FIRE STATION NO. 10 MODIFICATIONS

TITLE: FIRE STATION NO. 10 MODIFICATIONS
ARCHITECTURAL FLOOR PLAN AND DETAILS

RELIANCE STEEL COMPANY
1801 EIGHTH STREET NW.
ALBUQUERQUE, NM 87102

ONE-ANGLE A3

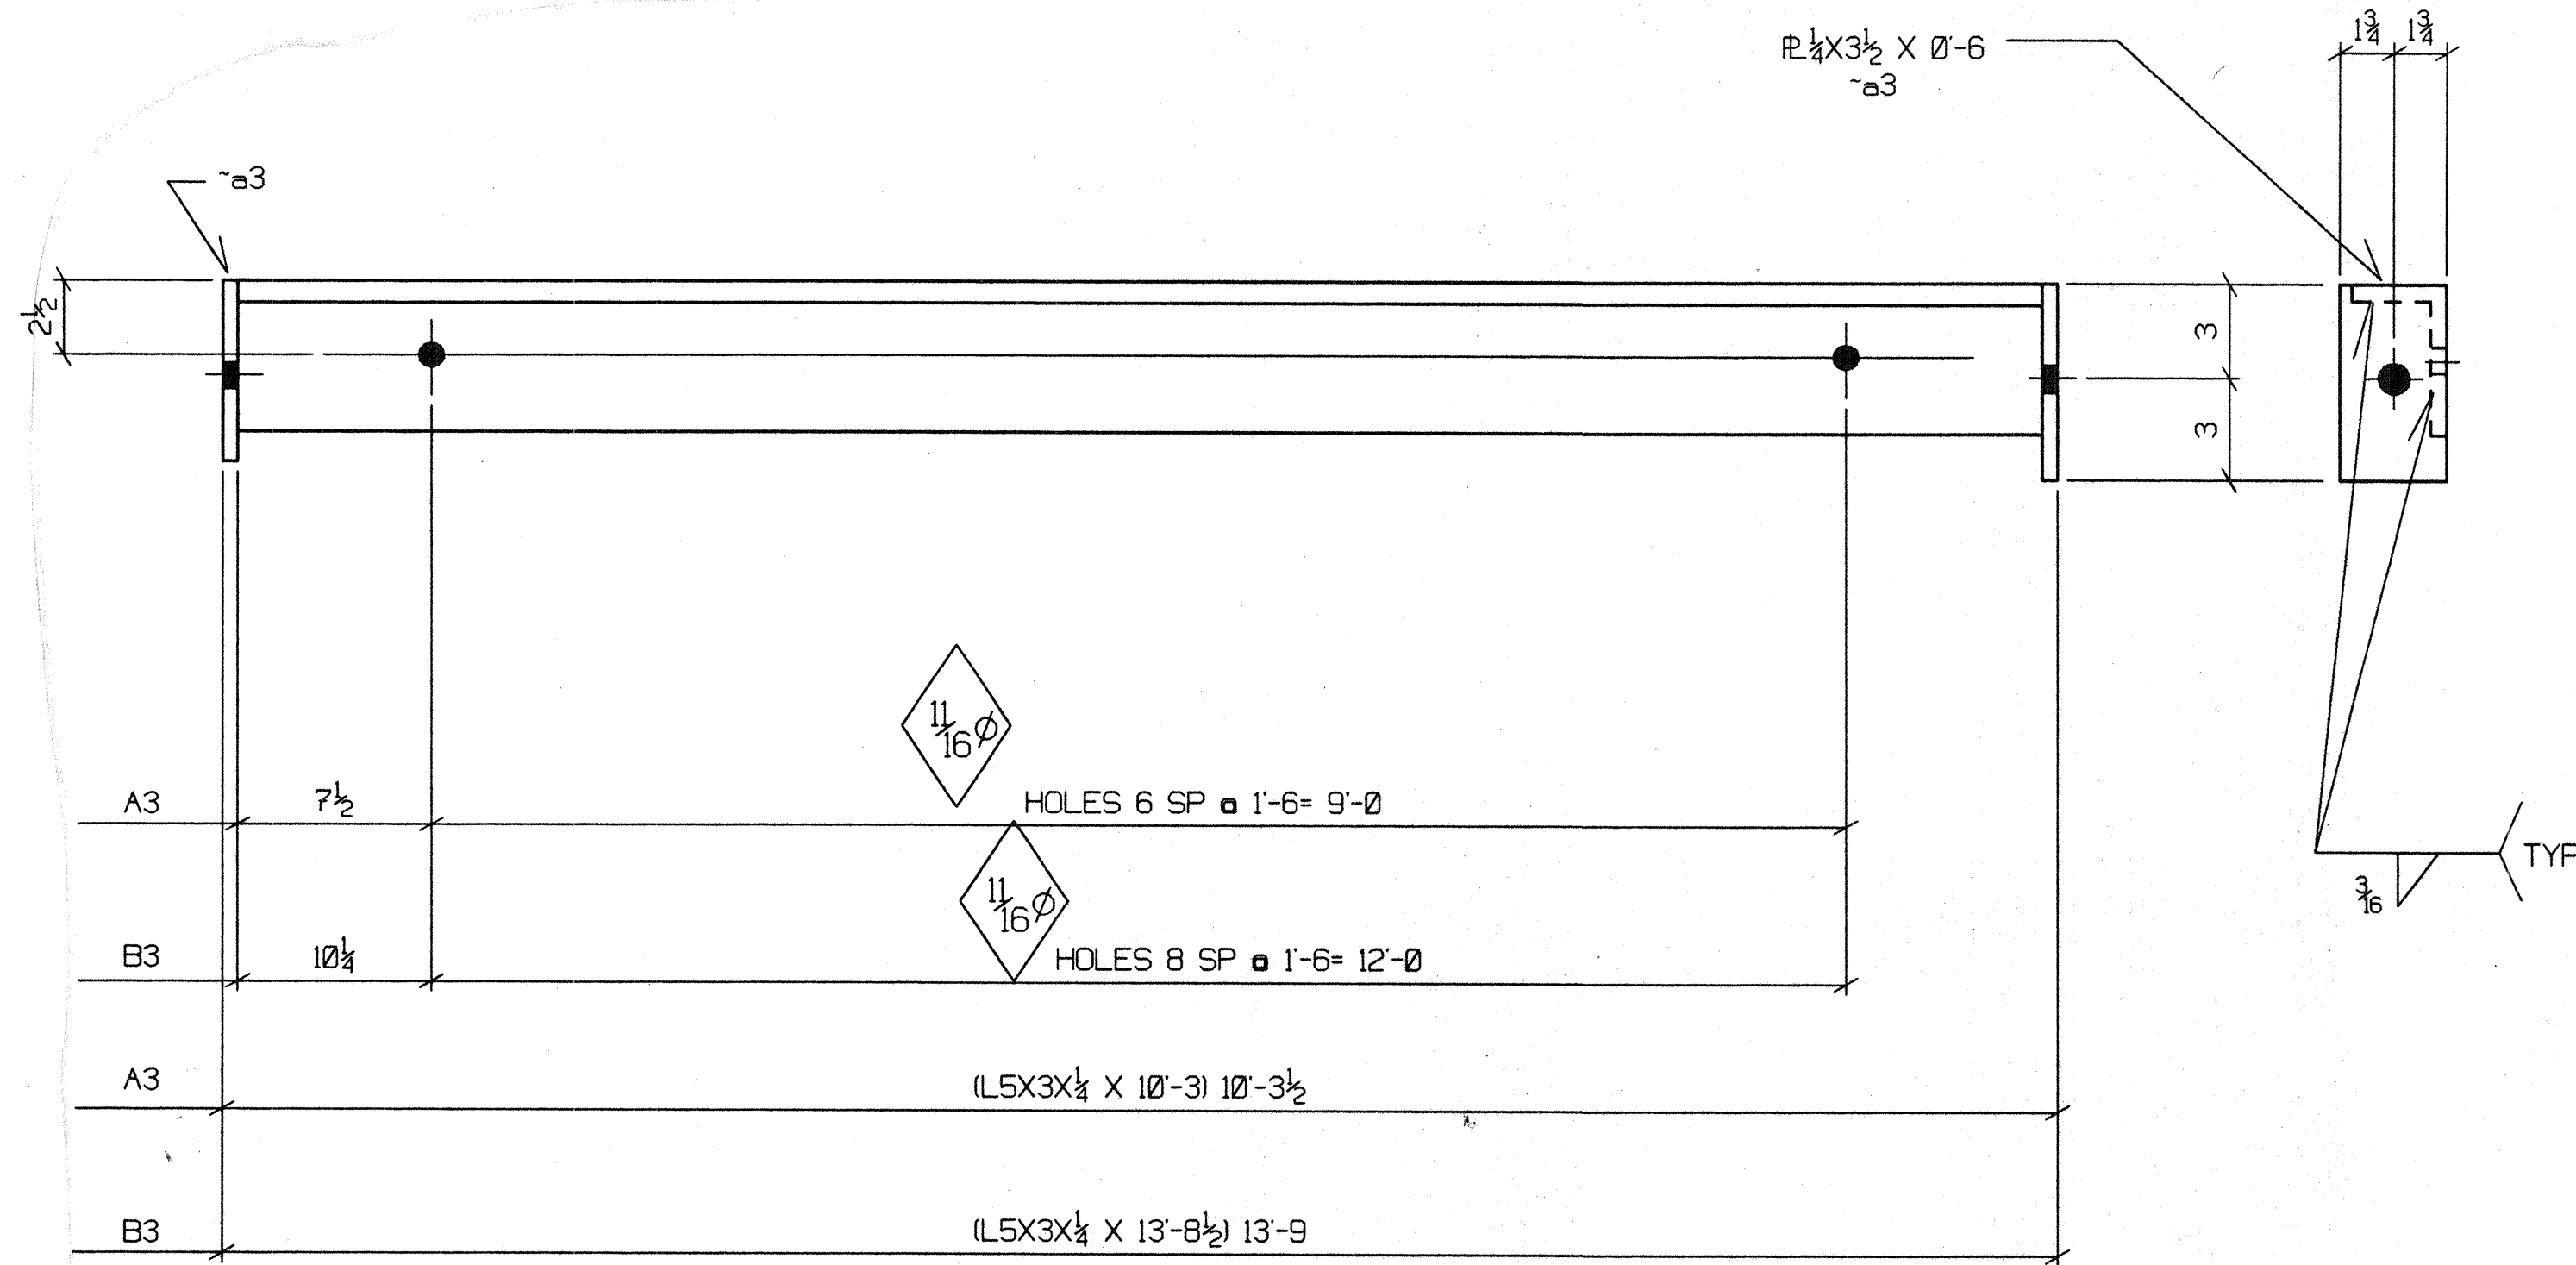
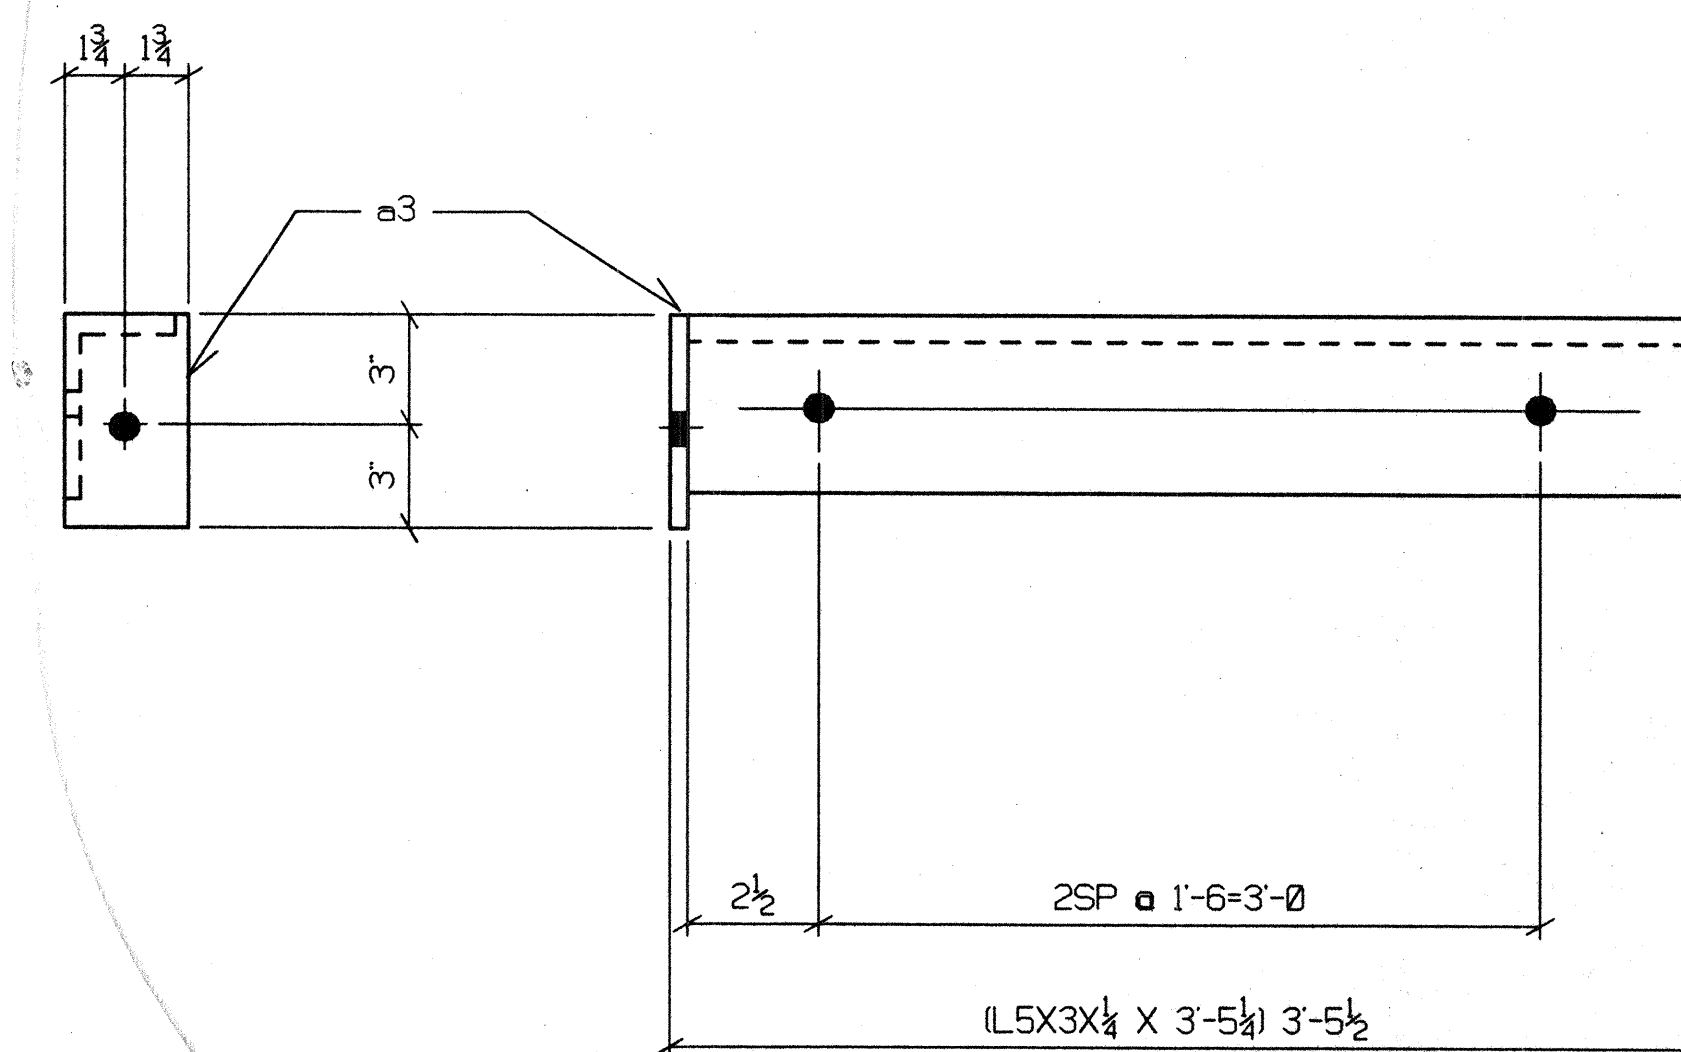
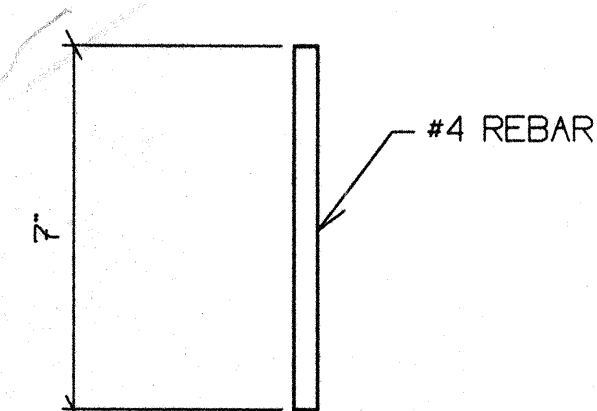
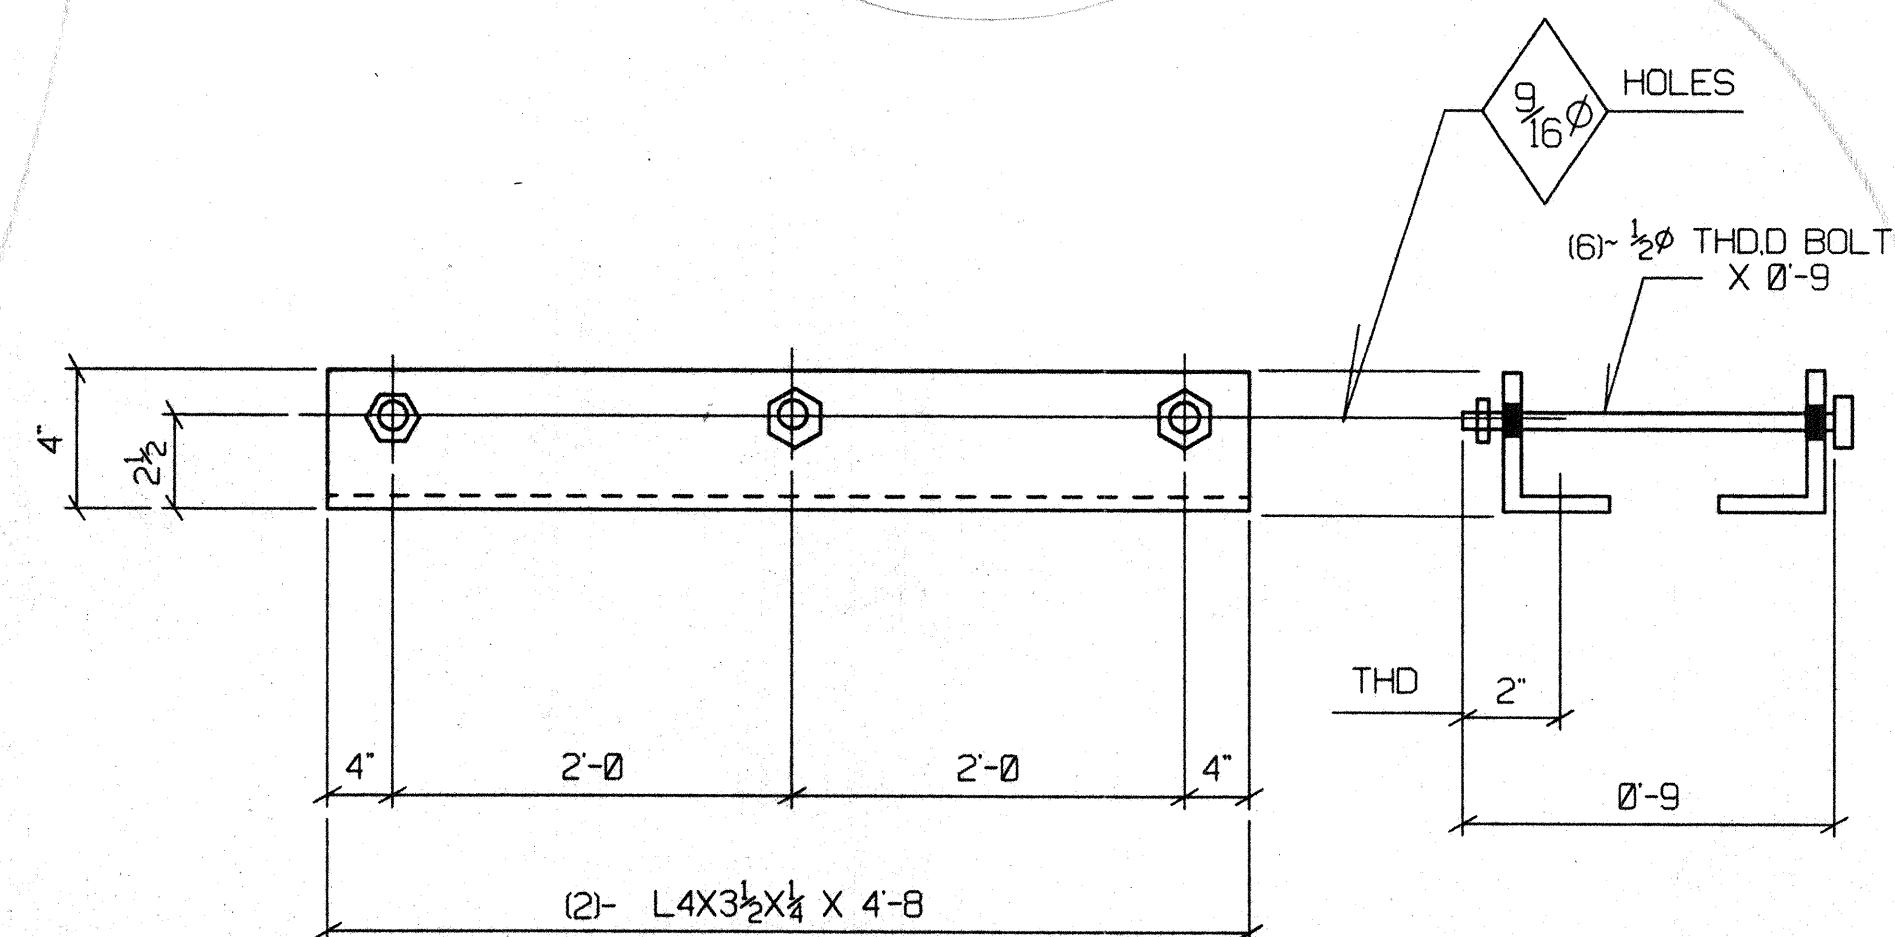
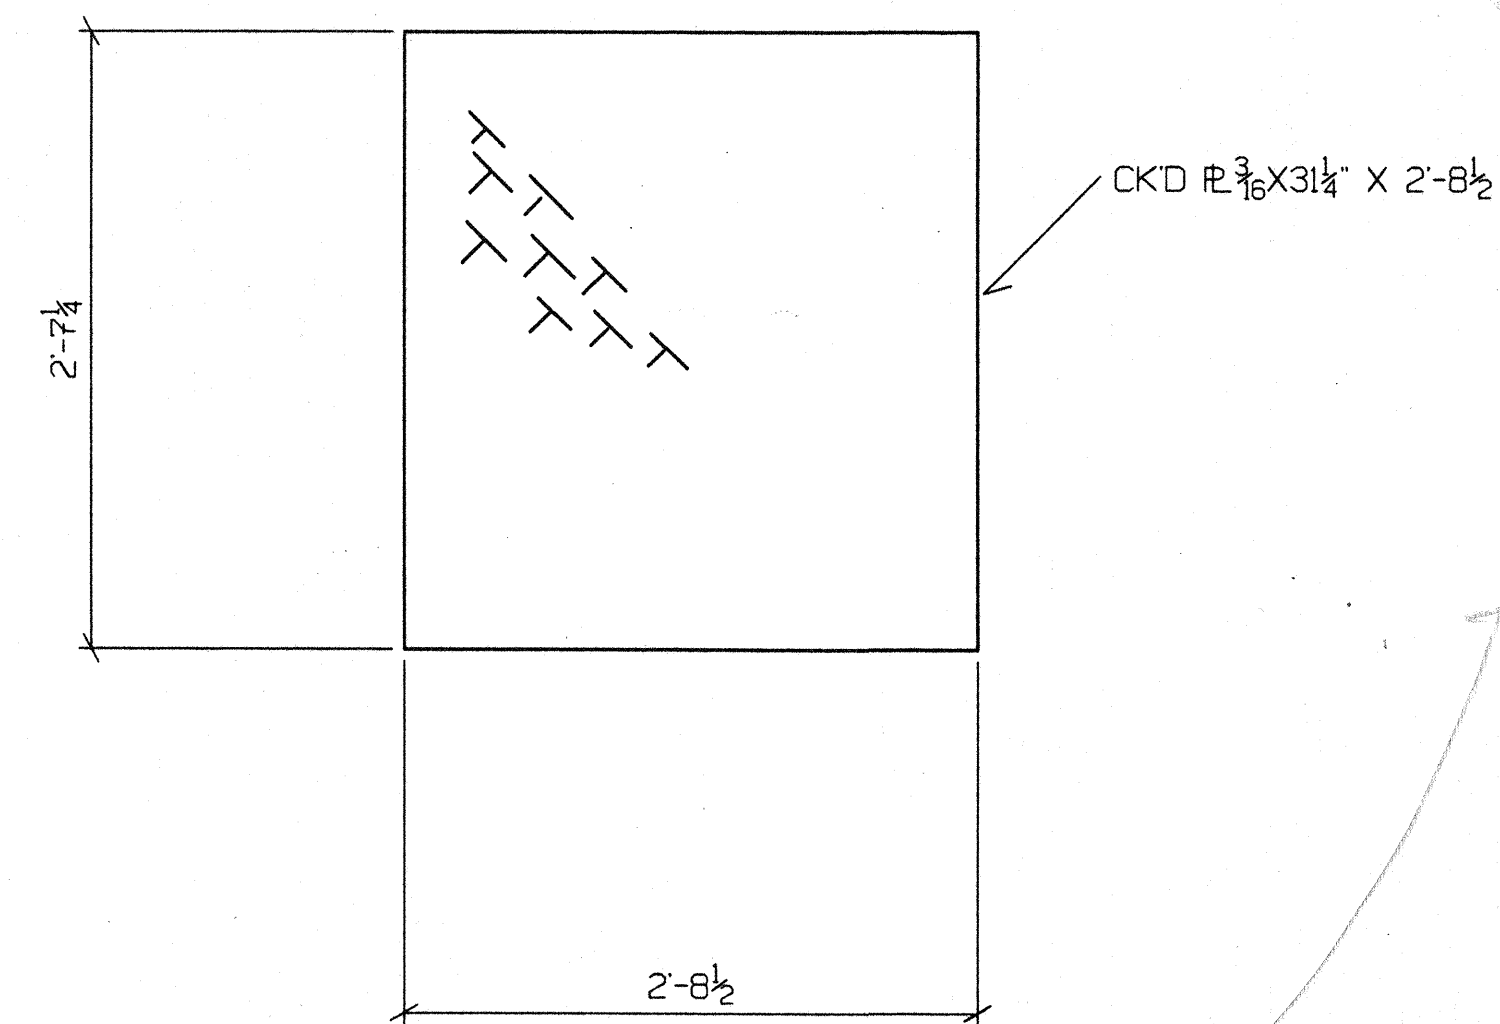
SHOP DRAWING REVIEW

A. NO EXCEPTIONS TAKEN
B. NO EXCEPTIONS TAKEN
SUBJECT TO CORRECTIONS NOTED
C. REVISE & RESUBMIT
D. REJECT - RESUBMIT
